At yesterday's Issue Specific Meeting you kindly invited me to ask 2 questions of the Applicant on Noise. I'm writing now due to concerns I have about the answers given, especially to question 2.

Whilst acknowledging that there was an assessment of noise impact during the operational phase on residential receptors I asked the Applicant to explain:

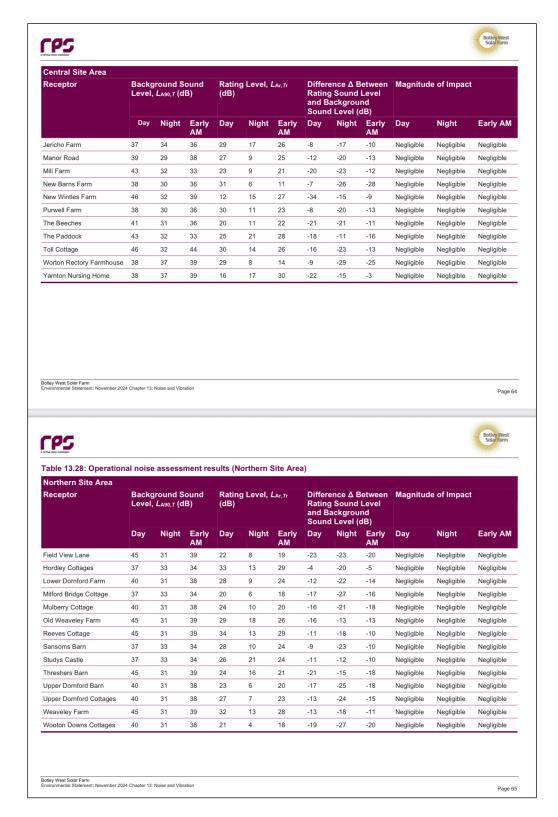
The only assessment of potential magnitude of impact during construction is table 13.25 which assesses any receptors <1344m from solar pile driving to be of **high** impact. There are over 5,000 within 1km but **none** of these have been assessed despite this general assessment.

The view expressed in para 13.9.16 is repeated in APP-212 Appendix 13.2 in paragraph 1.5.11 "the solar pile driving works would be very transient in nature and would move across each of the installation areas. Thus receptors may be exposed to high noise levels but this would occur only for a short period of time"

No evidence is provided for this statement or consideration of cumulative impact
